Cabling Transmission Parameters

Wayne Larsen CommScope

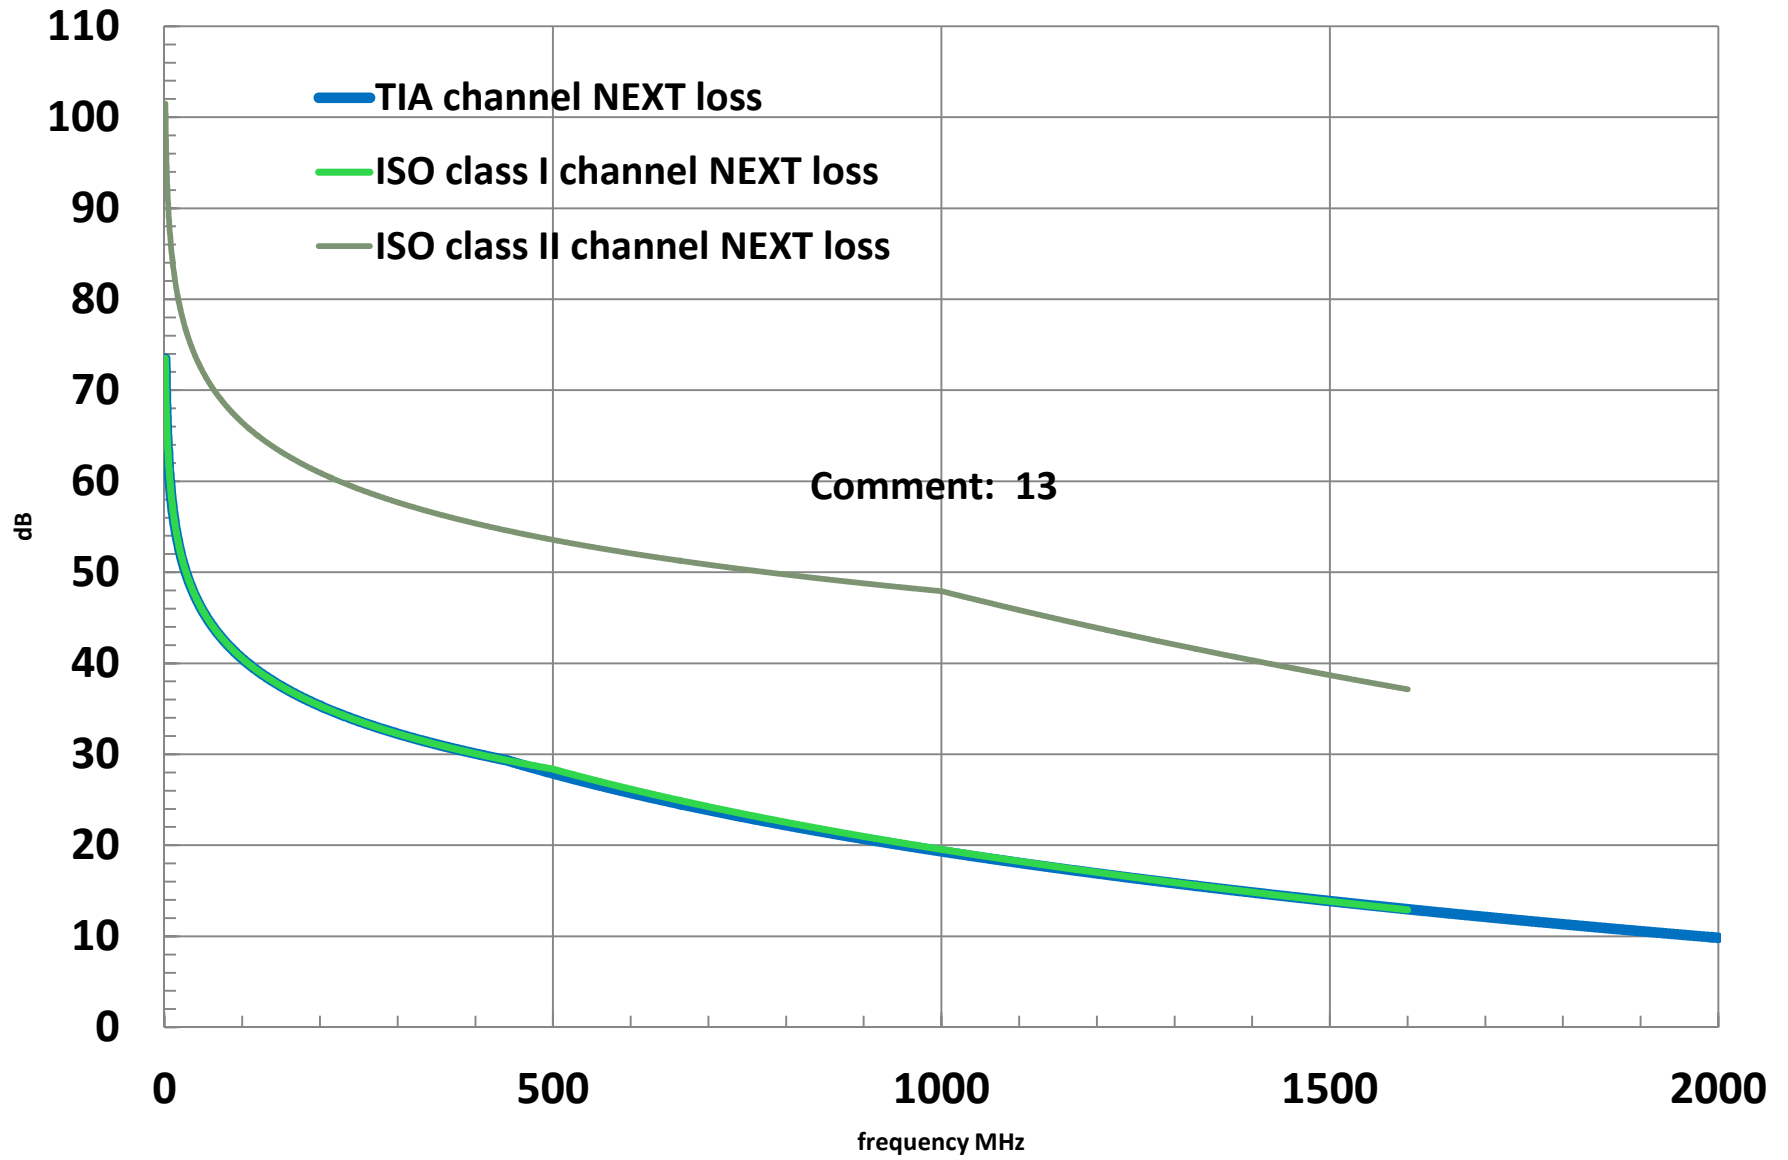
Comment: 13

ISO NEXT minus TIA NEXT

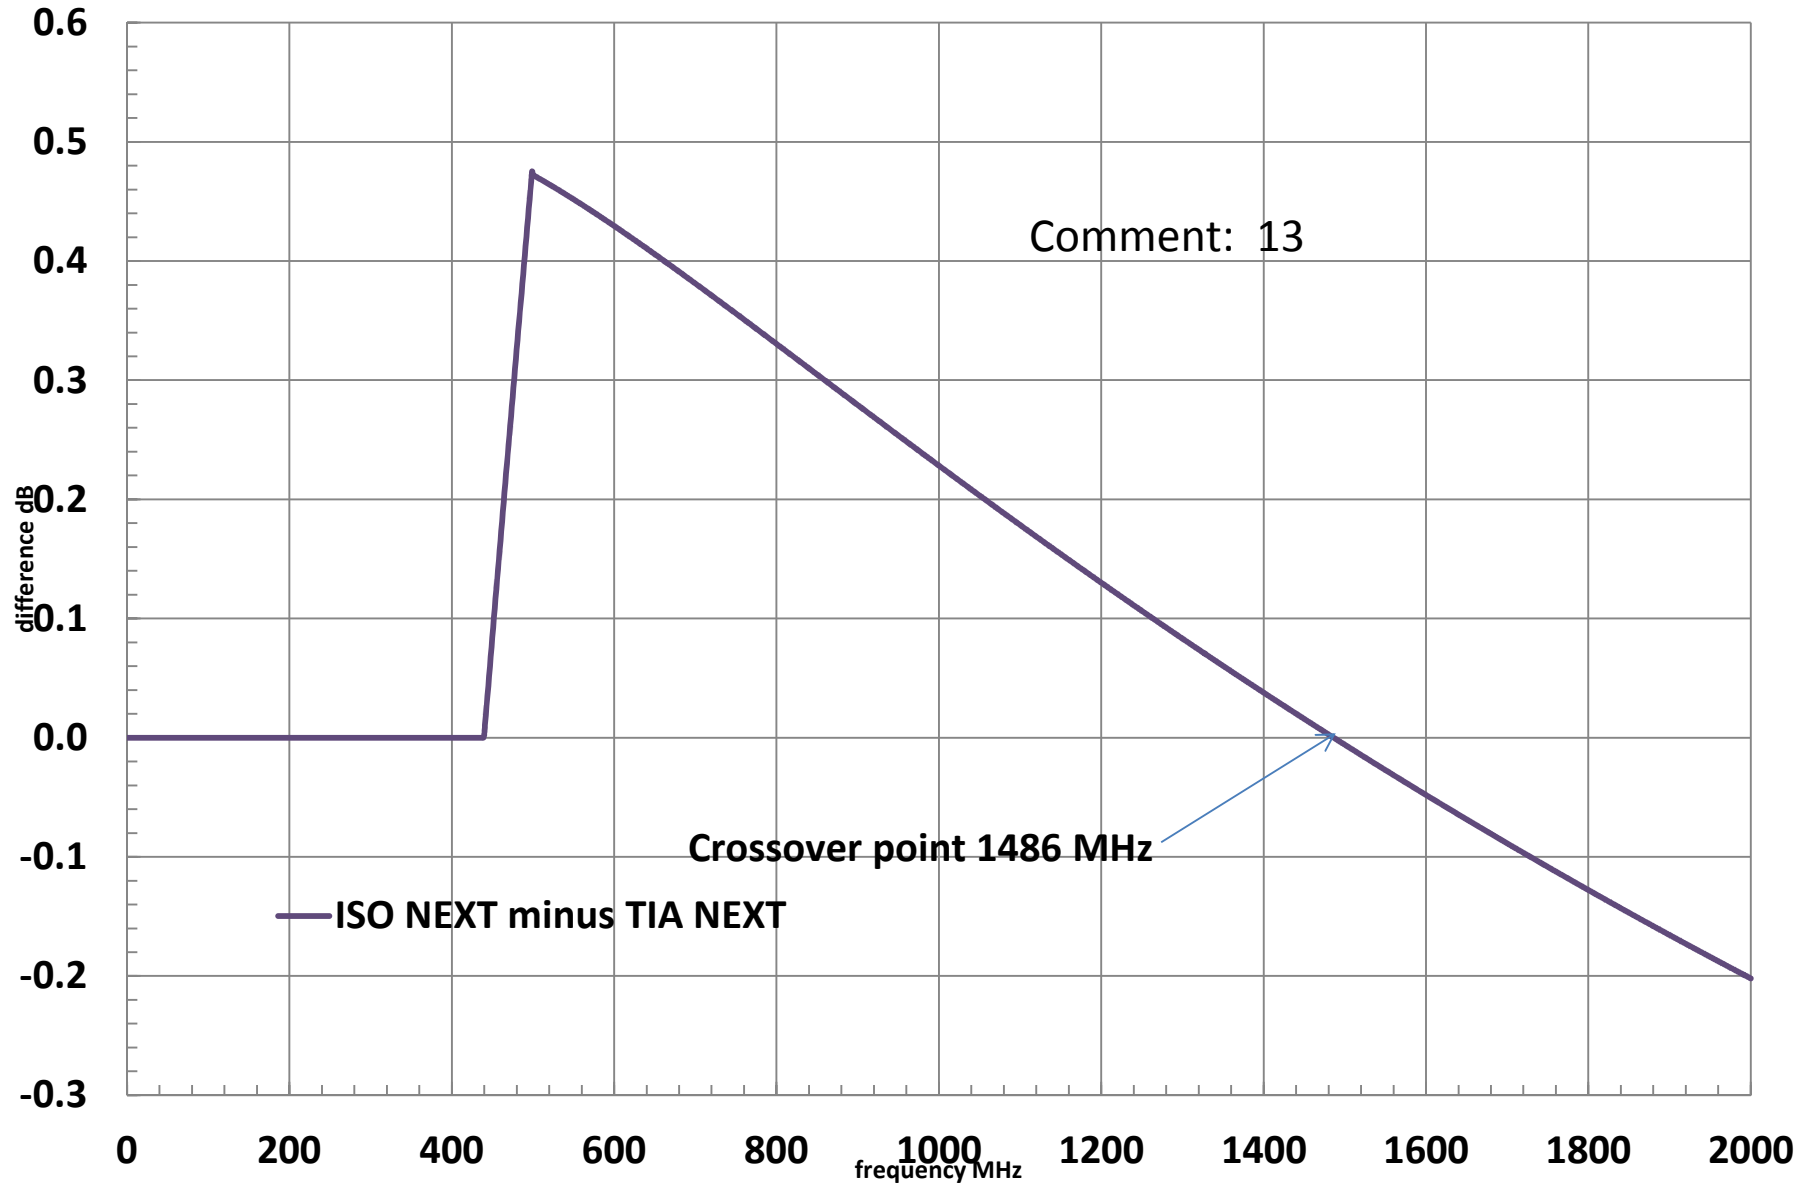
NEXT: Comment: 13

- TIA limit up to 0.5 dB lower than ISO in the middle range
- ISO limit up to 0.2 dB lower than TIA in the upper range
- Crossover point is 1486 MHz
- Choose TIA from 1-1486 MHz, ISO from 1486-2000 MHz

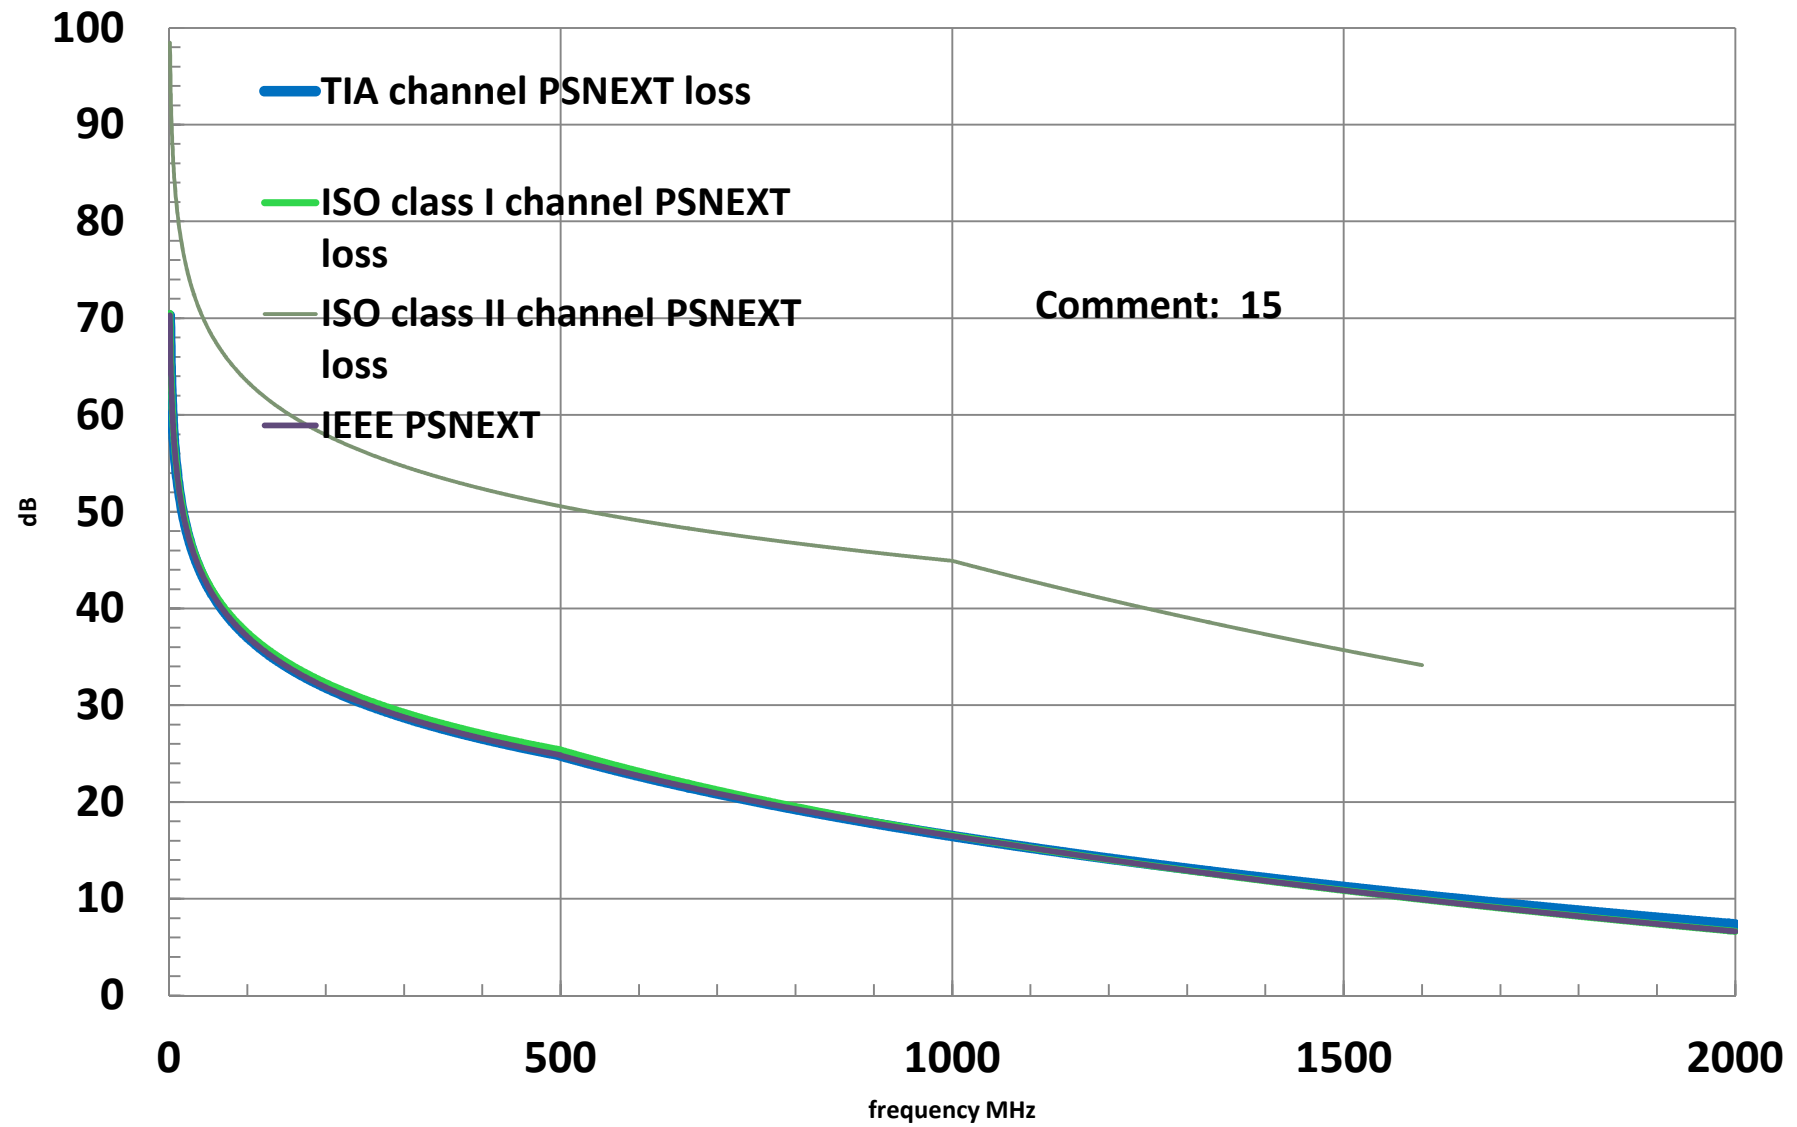
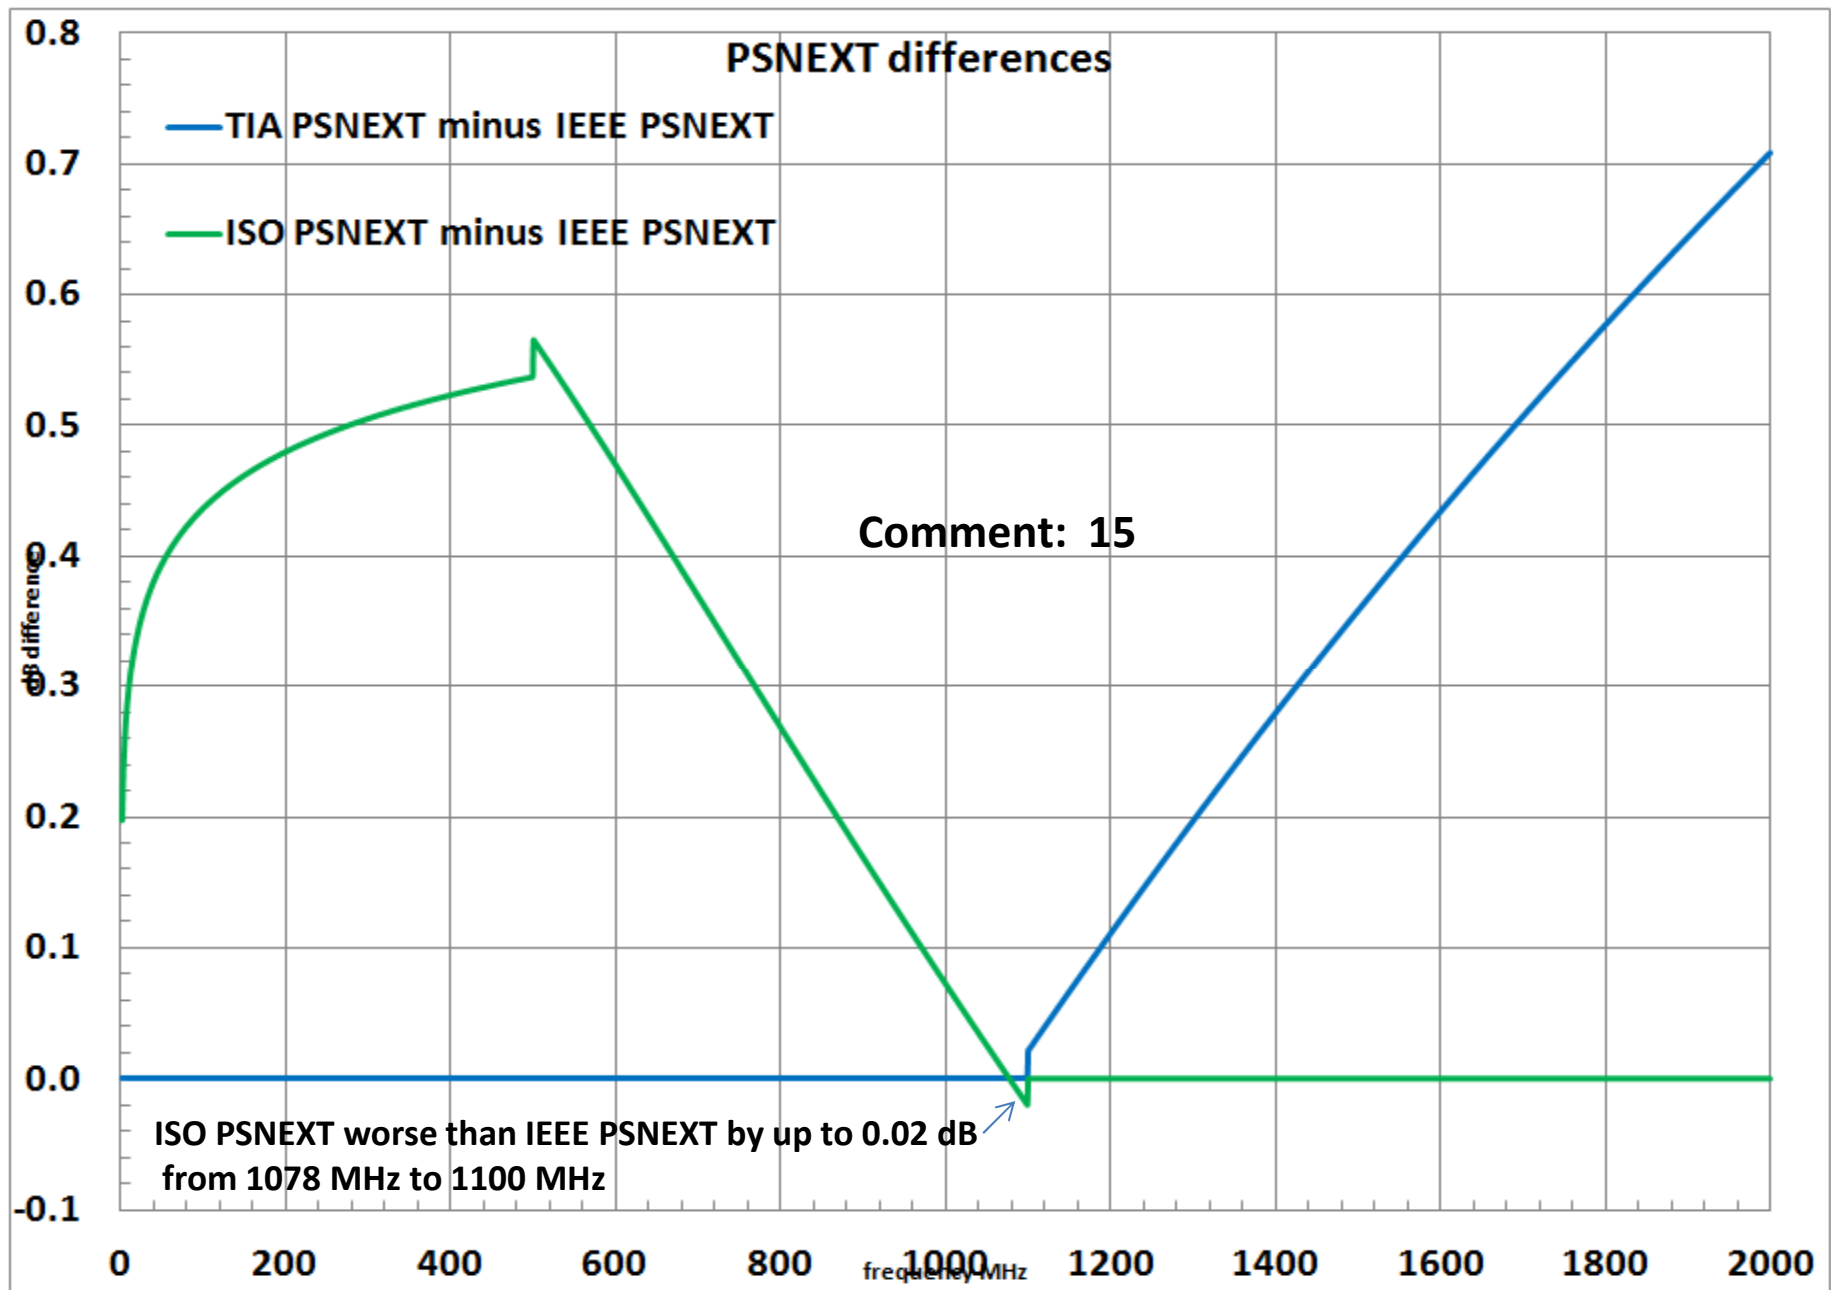
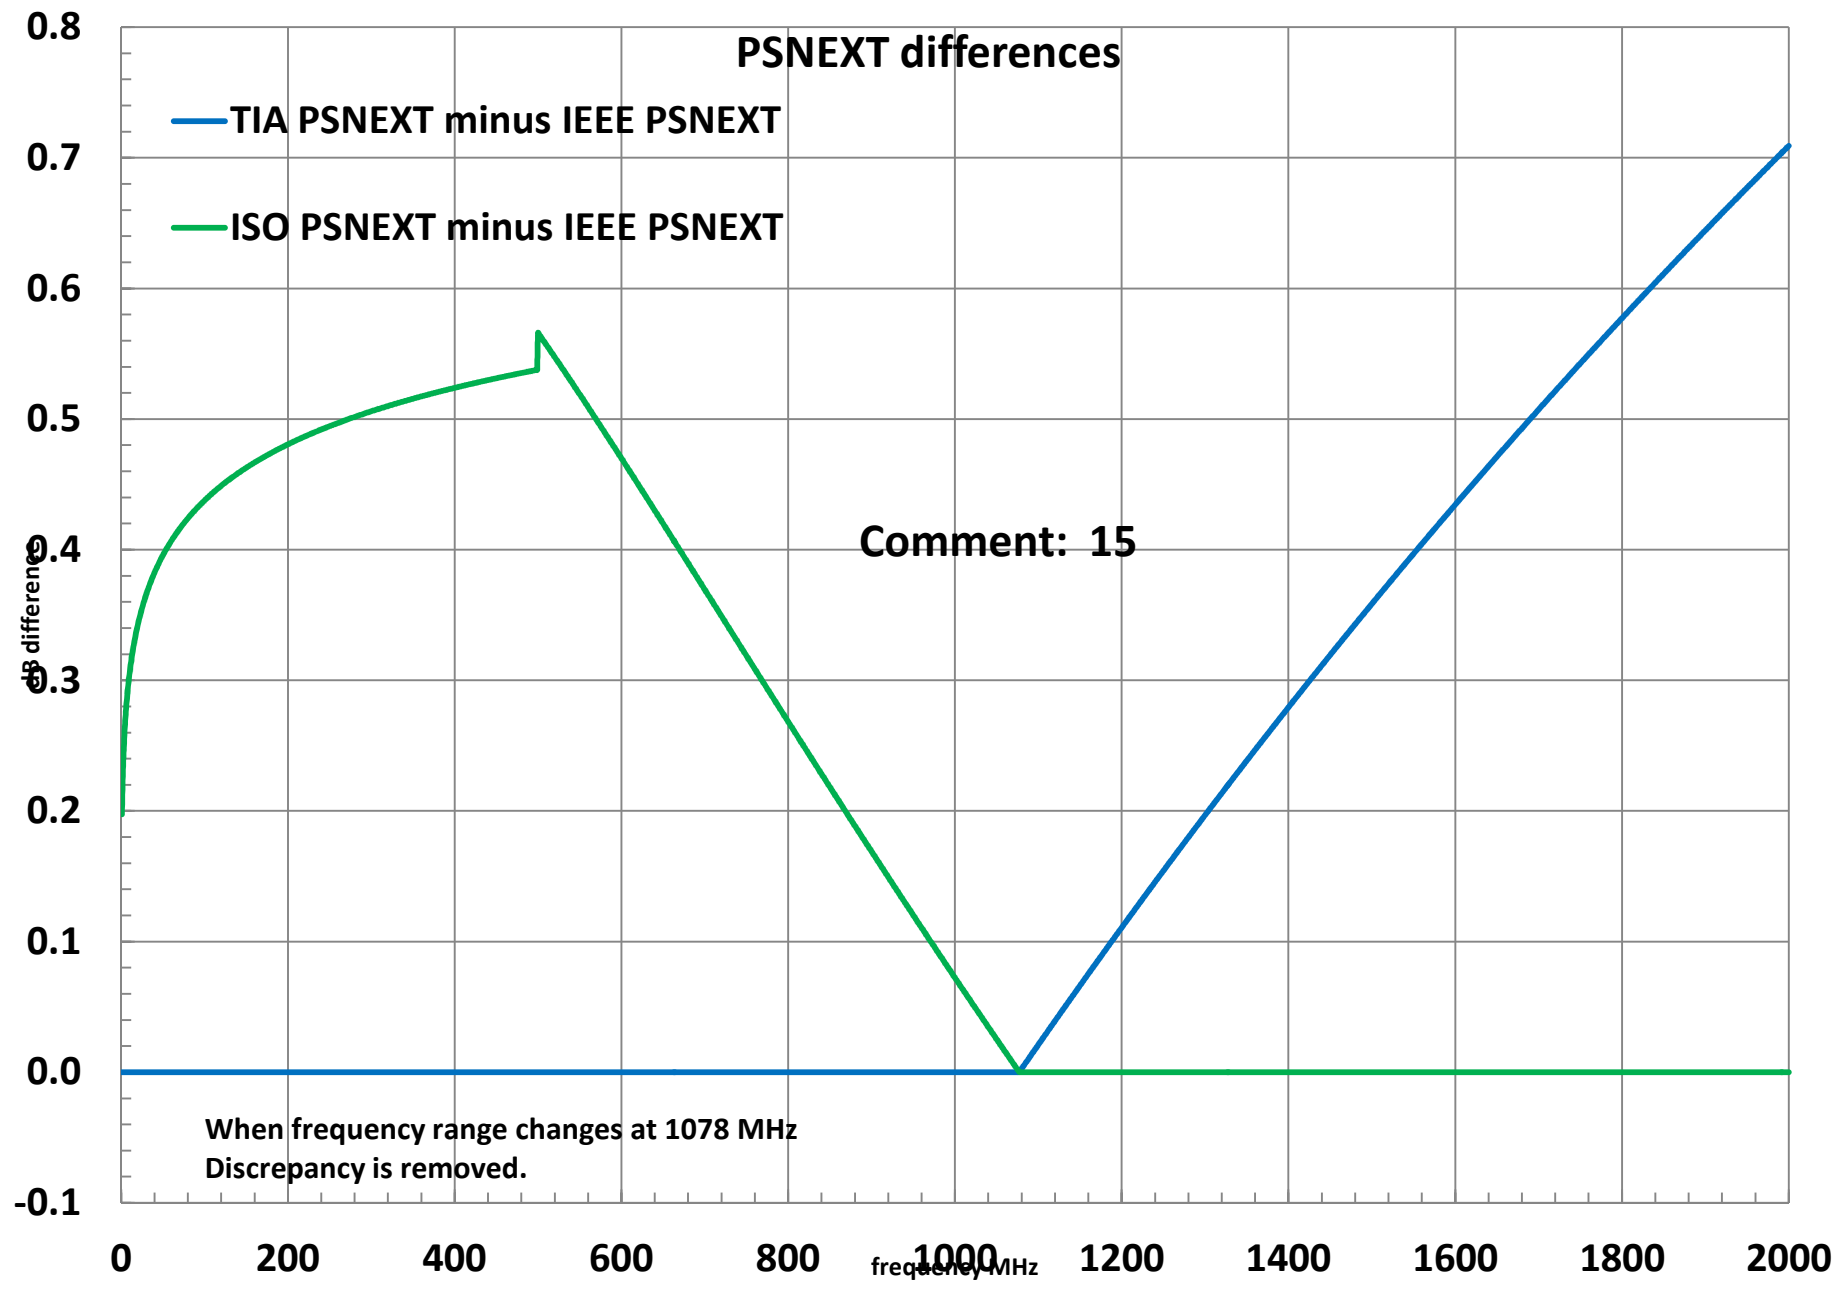
Comment: 15
